## REPORT ON EXISTING POOL SHELL AND PLUMBING

#### **Pool Specifications:**

### Core Sample #5: Deep End Floor

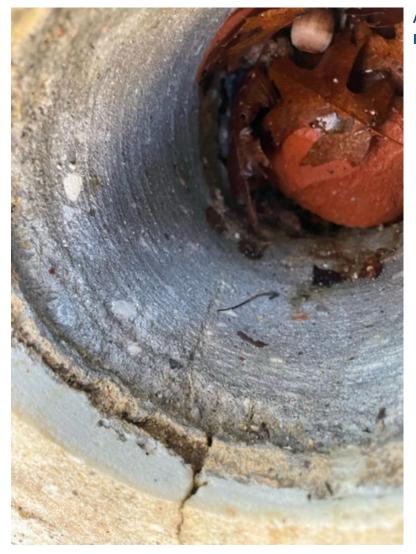
Thickness of core is 5" overall with approximately 4" of clean gunite and 1" contaminated layer with sand mix. 1/2" of plaster was found on this core.
